Traffic Engineering-Safety Guidance Fort Polk, Louisiana June 2001

Study Objectives

Concept sketch for the intersection of Chaffee and Exchange Rds

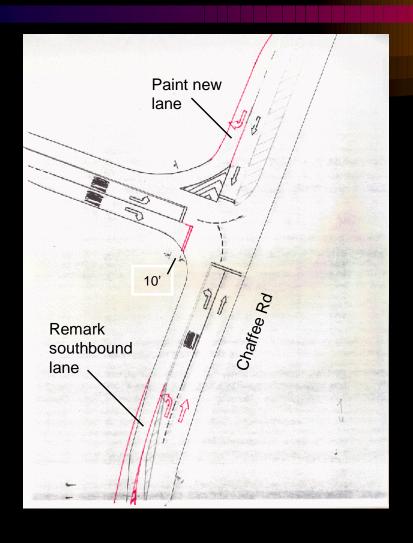
- By using a portion of the 10-ft shoulder on the southbound Chaffee Rd approach, provide a separate 60-ft long right-turn lane.
 - Motorists occasionally drive on this shoulder to make right turns and have the potential of being hit by right-turning motorists who stay within the marked travel lane.
- Install a YIELD sign for this right-turn movement.

- Install black-on-white, rectangular NO DRIVING ON SHOULDER signs on the southbound and eastbound approaches approximately 150 feet prior to the intersection.
 - This 24" x 30" regulatory sign is used throughout Louisiana.
- Move the Stop line for the right-turn lane on eastbound Exchange Rd forward by 10 ft.
 - This will give motorists in this lane a better view to the north, and place them closer to the intersection and thus allow them to clear it faster.

Concept sketch for the intersection of Chaffee and Magazine Rds

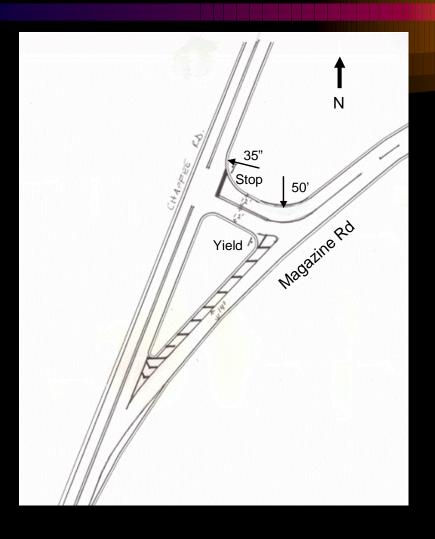
- Modify this intersection so that it provides a single, right-angle
 Magazine Rd approach onto Chaffee Ave.
 - This design provides a much better view of the Chaffee Ave north leg for Magazine Rd motorists turning south .
 - It essentially reduces the vehicle conflict zone to only one location.
 - It eliminates the existing confusion regarding right-of-way.

Concept sketch for the intersection of Mississippi and Alabama Aves with 3rd St

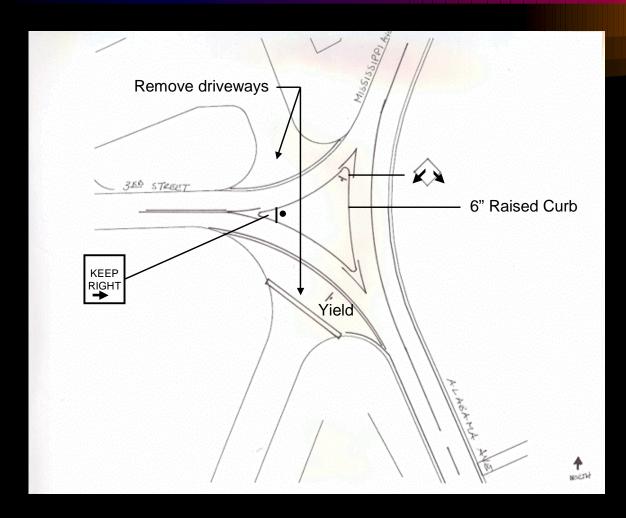
- Construct a raised, 6-in island to clearly define travel paths and reduce the open expanse of pavement.
 - This design will reduce vehicle conflict points to only one, where 3rd St traffic merges with the outer lane of southbound Alabama Ave.
 - The confusing view for southbound Mississippi Ave motorists will be eliminated.
- Close access to the parking area on old Mississippi Ave.

Service Station exit and Alabama Ave

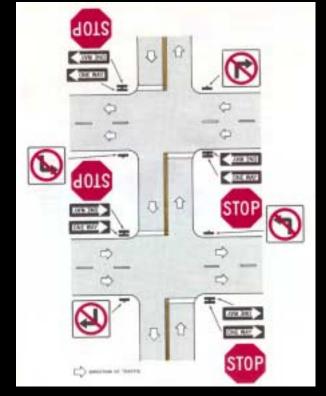
- Provide one-way signs to clearly show that right turns are not allowed when exiting the service station onto one-way, southbound Alabama Ave.
 - This problem is typical of the inadequate manner Alabama Ave, Georgia Ave, and other one-way streets are signed.
